Name Of Dam: DOUTHAT DAM

PHASE I INSPECTION REPORT

NATIONAL DAM SAFETY PROGRAM

GILBERT ASSOCIATES, INC.
SEPTEMBER, 1978

FIGURE 3

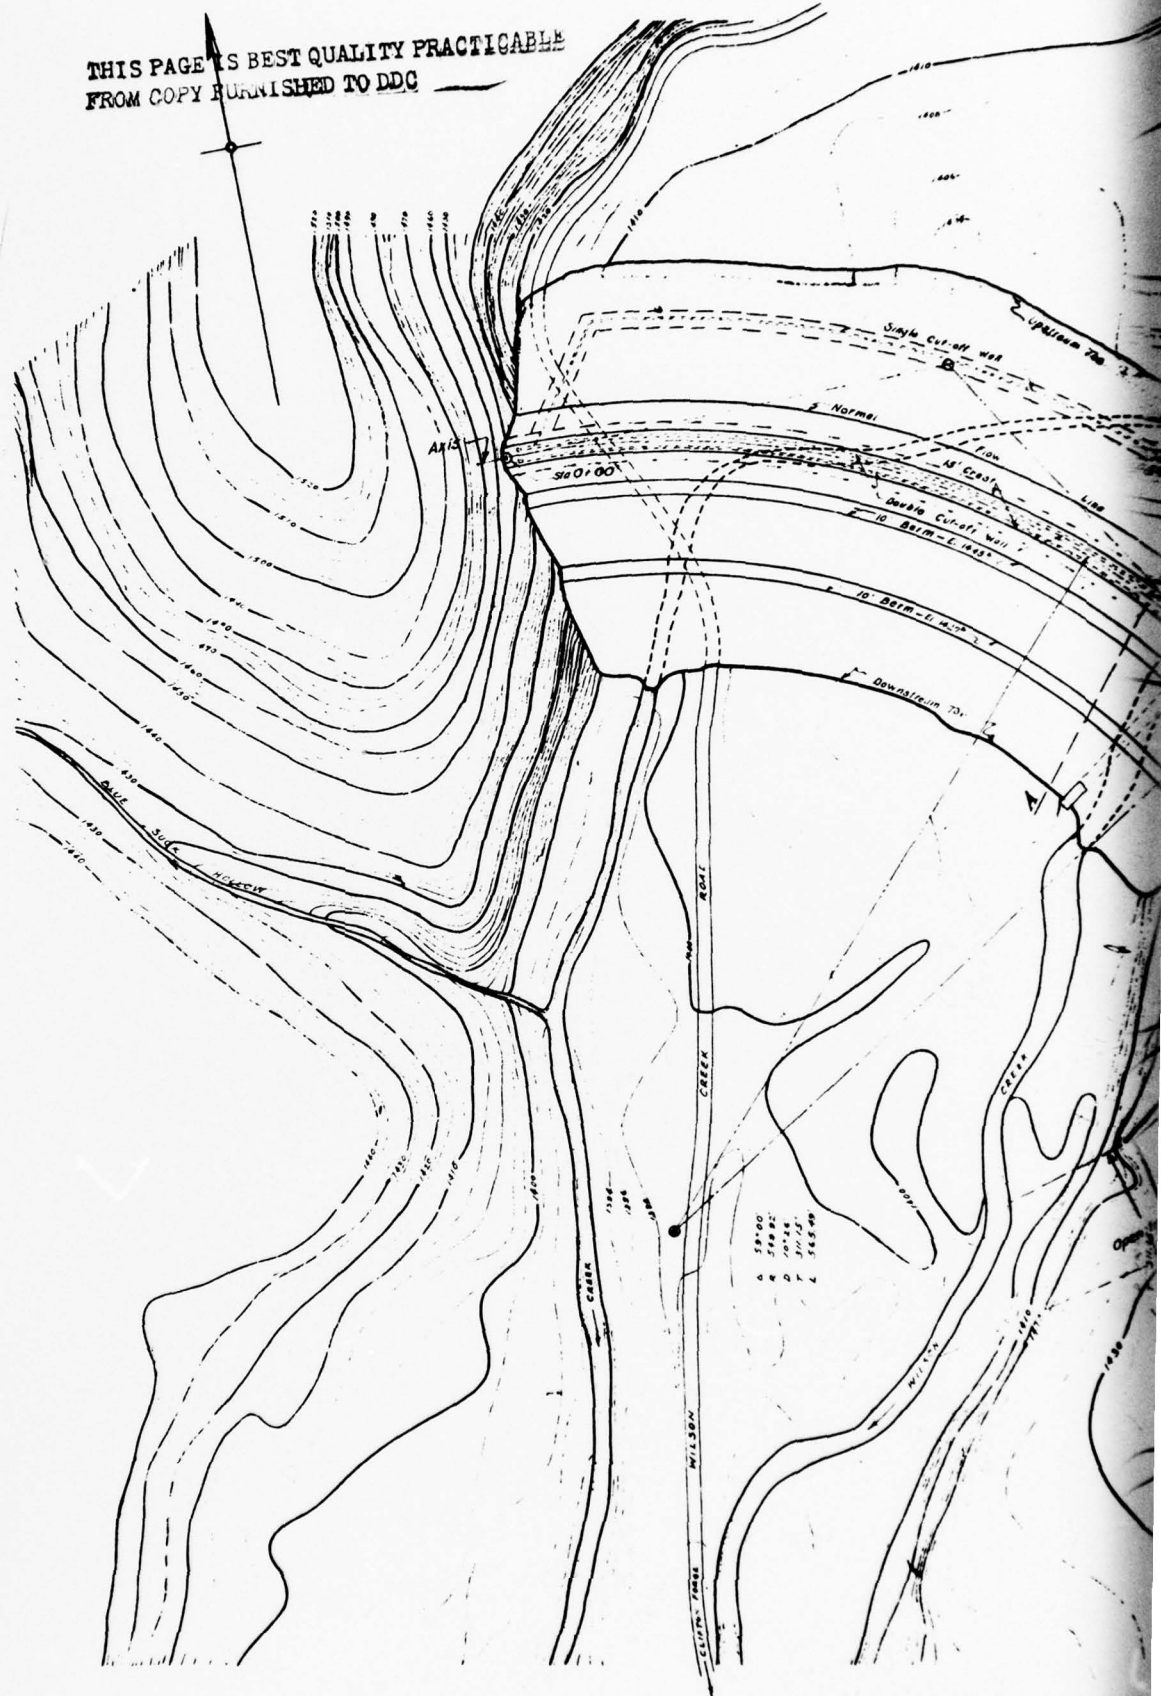
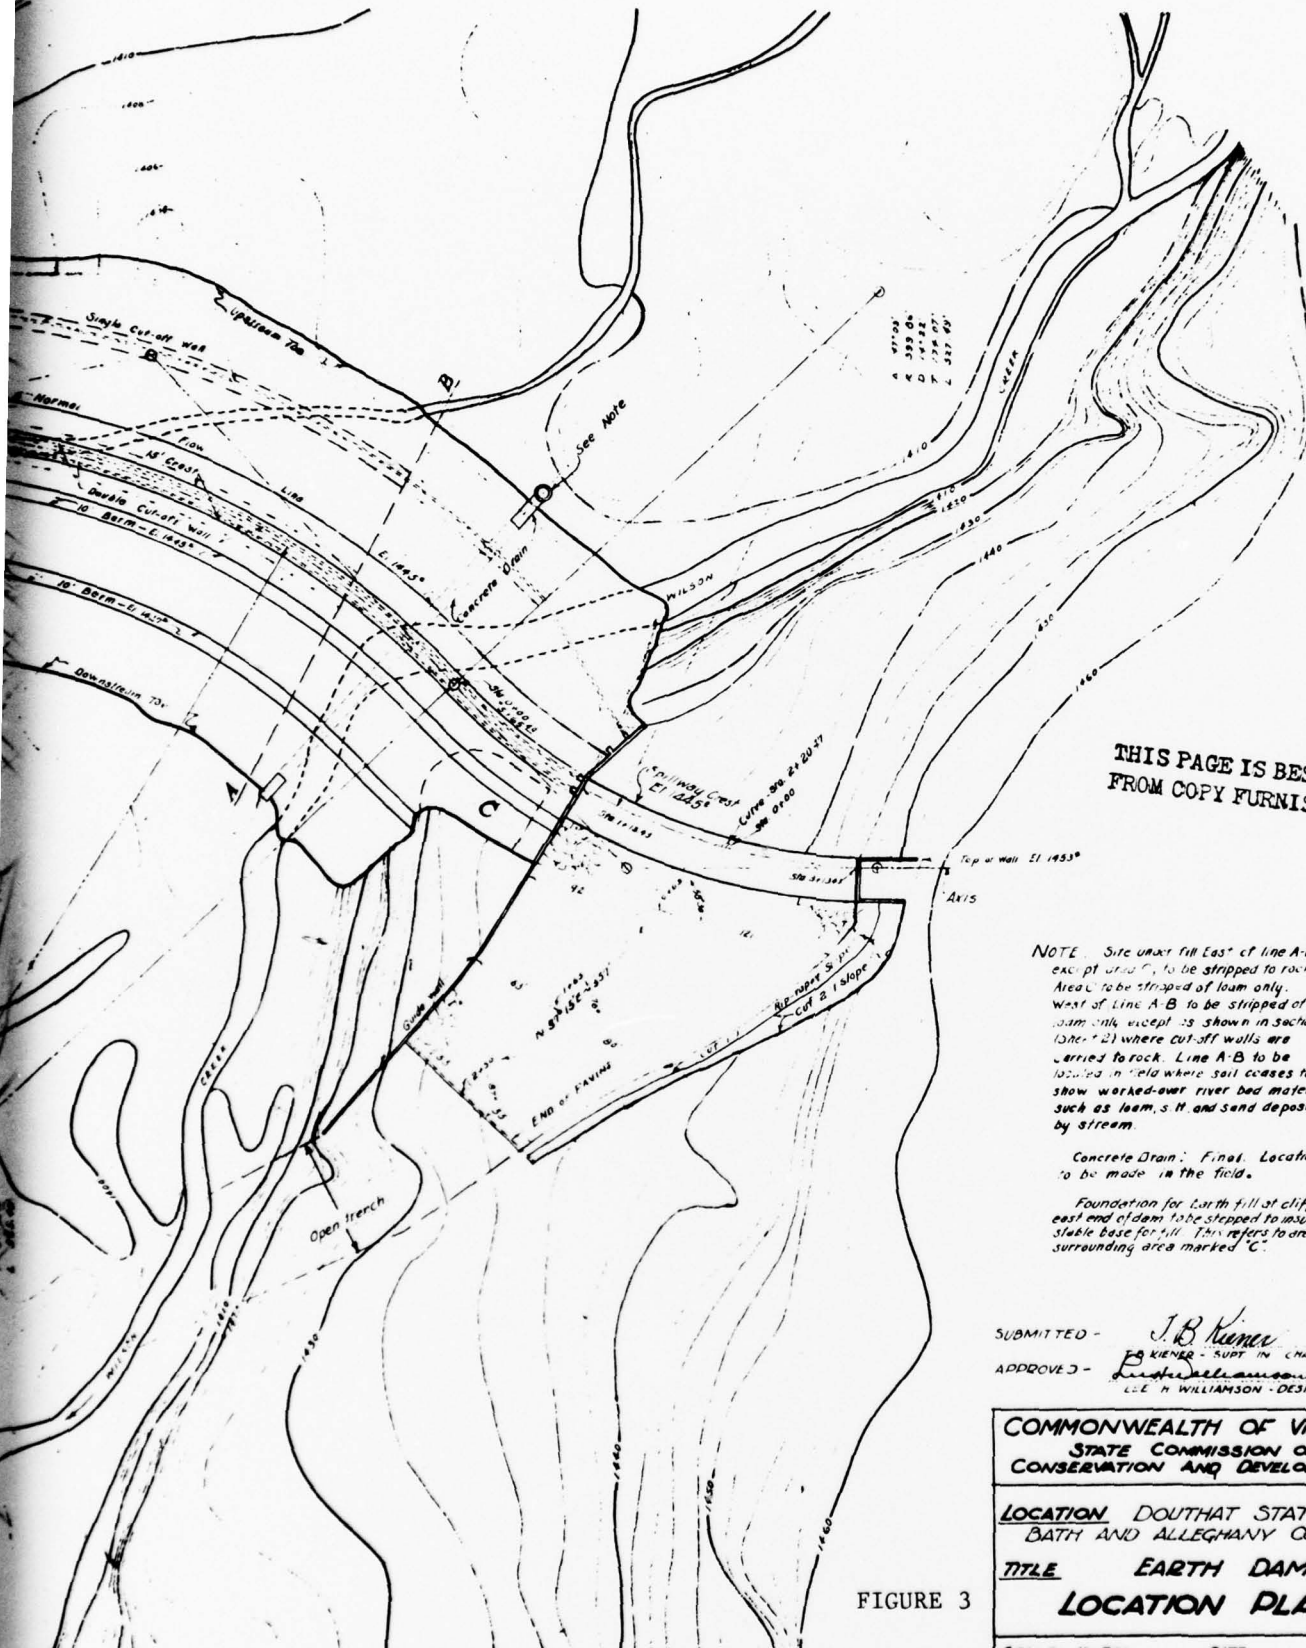
The drawings show that the impervious earth core and the concrete cutoff walls were designed to be founded on bedrock. The site under fill east of line A-B (see Figure 3, Appendix I) was to be stripped to rock. West of line A-B the site was to be stripped of loam only. Line A-B was to be located in the field where soil ceases to show reworked alluvial deposits, such as loam, silt, and sand deposits. The foundation for earthfill at the cliff near the east end of the dam was to be stepped to provide a more stable base for the fill.

2.4 Evaluation: There are no foundation exploration and construction data, or design calculations and data available, and the description of the zoned material shown on the design drawing was inadequate to enable a complete evaluation of the dam stability. The spillway channel profile shown in the design drawing is not consistent with what was observed in the field; i.e., a drop at the end of the plunge pool of the spillway was not shown on the design drawings.
